Access Compliance Report

Public Rights-of-Way (Curb Ramps)

Intersection ID: 28389	Main Street: ARDREY_KELL_RD	Cross Street: LANCASTER_HY	Location: NW
ADA ID: 100CCD2816D2	Ramp Type: Para	Initial Pass/Fail: Fail	Overall Compliance: No
		Severity Score: 25

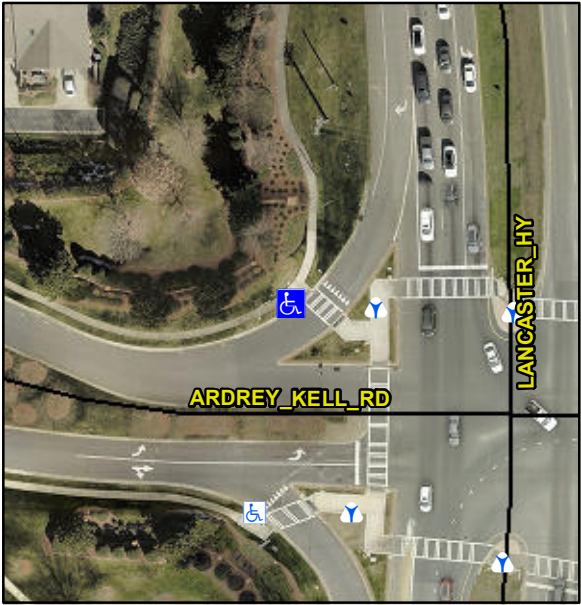
Codes/Mitigation Info/Possible Solution			Field Measurements/Component Compliance		
	Possible Solutions:		Compliance	Description	Data
	Remove & Replace Entire Ramp.		N/A	Ramp Length LT (in)	32.0
			Yes	Ramp Width LT (in)	57.0
			Yes	Ramp Slope LT (%)	5.2
			Yes	Ramp XSlope LT (%)	0.3
			N/A	Landing Length (in)	N/A
			N/A	Landing Width (in)	N/A
			N/A	Landing Slope (%)	N/A
			N/A	Landing X Slope (%)	N/A
			N/A	Landing Curb? (Y/N)	N/A
<p>Surveyor Notes:</p> <p>N/A</p> <p>PROW/ADA:</p> <p>R304.3.2</p>			N/A	Shared Landing?	N/A
			N/A	Gutter Ponding?	N/A
			N/A	Gutter Lip Ht (in)	N/A
			N/A	Painted X Walk1?	Yes
				X Walk 1 Direction	To SE
			N/A	X Walk 1 Width (in)	110.0
				X Walk 1 Slope (%)	4.8
				X Walk 1 X Slope (%)	1.7
			N/A	Ramp inside XWalk1?	Yes
				Road Slope (%)	N/A
<p>Street 1 Name</p> <p>Stop Condition-Street 1</p> <p>Street 2 Name</p> <p>Stop Condition-Street 2</p>			N/A	Road X Slope (%)	N/A
			N/A	Any Obstructions?	N/A

Obstruction Type	
			N/A		
Total Cost:		\$ 1600.00	N/A		N/A
			Yes	Surface Condition? (G/P)	Good
			N/A	Curb Slope (%)	2.1
